Access Compliance Report

Public Rights-of-Way

(Curb Ramps)

Intersection ID: 44015	Main Street: ATWATER_LN	Cross Street: MANTARIO_DR	Location: SE
ADA ID: CAA1C8C48988	Ramp Type: BlendTrans1	Initial Pass/Fail: Fail	Overall Compliance: No
		Severity Score: 30

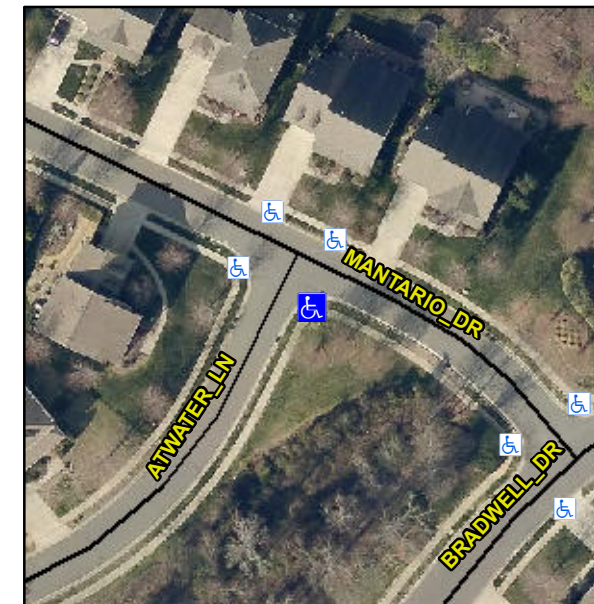
R304.5.1, R304.5.3

Compliance	Description	Data	Compliance	Description	Data
N/A	Ramp Length (in)	48.0	Yes	BlendTrans Slope (%)	1.8
No	Ramp Width (in)	35.0	No	BlendTrans XSlope (%)	5.3
N/A	Flare Type LT	N/A	N/A	Flare Type RT	N/A
N/A	Flare Slope LT (%)	N/A	N/A	Flare Slope RT (%)	N/A
N/A	Flare Traversable LT?	N/A	N/A	Flare Traversable RT?	N/A
N/A	Landing Length (in)	N/A	N/A	DWS Provided?	N/A
N/A	Landing Width (in)	N/A	N/A	DWS Contrast?	N/A
N/A	Landing Slope (%)	N/A	N/A	DWS Length (in)	N/A
N/A	Landing X Slope (%)	N/A	N/A	DWS Full Width?	N/A
N/A	Landing Curb? (Y/N)	N/A	N/A	DWS Offset (in)	N/A
N/A	Shared Landing?	N/A			
N/A	Gutter Ponding?	N/A	N/A	Gutter Slope (%)	N/A
N/A	Gutter Lip Ht (in)	N/A	N/A	Gutter X Slope (%)	N/A
N/A	Painted X Walk1?	No	N/A	Painted X Walk2?	No
	X Walk 1 Direction	To NE		X Walk 2 Direction	To NW
	X Walk 1 Width (in)	N/A		X Walk 2 Width (in)	N/A
	X Walk 1 Slope (%)	0.6		X Walk 2 Slope (%)	2.3
	X Walk 1 X Slope (%)	4.9		X Walk 2 X Slope (%)	2.5

Remove & Replace Curb Ramp With Two New Directional Ramps or Equivalent.
